**From:** [Mahaffey, Brett](#)  
**To:** [Audra Dye](#); [Mahaffey, Brett](#)  
**Subject:** [EXTERNAL] RE: 9120 Dwight - A few more questions on application  
**Date:** Wednesday, October 4, 2023 2:15:07 PM  
**Attachments:** [image003.png](#)  
[image007.png](#)  
[image001.png](#)  
[image002.png](#)  
[image004.png](#)  
[image008.png](#)  
[image009.png](#)

**Subject:** RE: 9120 Dwight - A few more questions on application

**Subject:** 9120 Dwight - Questions on Application

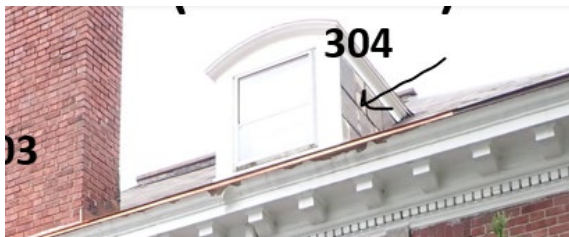
The 1941 "erection of a dormer" that is super interesting.

I found a permit from 1941 that was for the erection of a dormer, 2 bedrooms and a bath on the third floor. Based on the photos you submitted, I am assuming this may be the wider dormer facing the east (307 a&b, 308 a&b). Do you think that is correct?

I'm going to say that everything on that 3<sup>rd</sup> level was possibly done at that time because that entire area is laid out awkwardly.

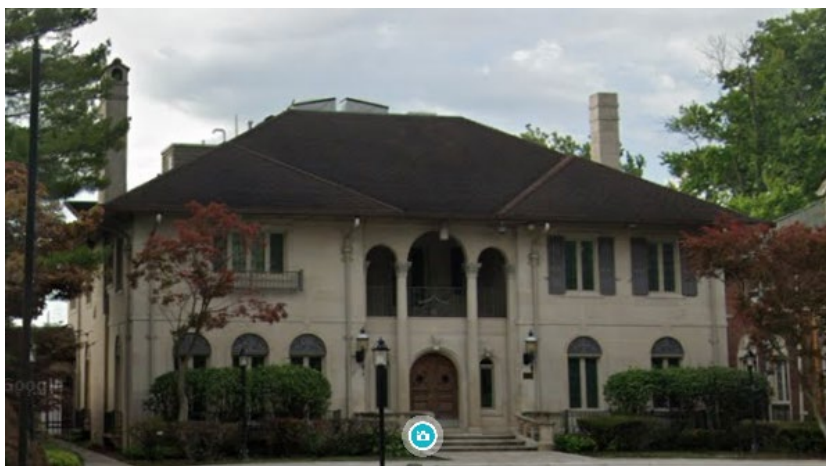
This area is super cool and none of the homes look anything alike. The closest roof that I found in the immediate area would be the Mannoogian mansion and they don't have any windows on the third level – is it possible this house had those front windows and side windows installed at the same time as the 2 bedrooms and bathroom?

305 and 306 are in one of the two bedrooms upstairs (there were only 2 bedrooms, a bathroom, and 2 storage areas that I can remember). 307a/b was another bedroom and 308 a/b was the bathroom. They are all cased in OG casing and not the fluted that was used in the lower two levels.

The 301, 302, 303, 304 the area they are in is so narrow there is no trim installed, but most of these third levels that were built with the house are unfinished from the couple I've been in.

301, 302, 303, and 304 are all located in storage areas and hard to get to. These rooms weren't "finished" except for some drywall – the exterior "siding" is similar to the other rooms.
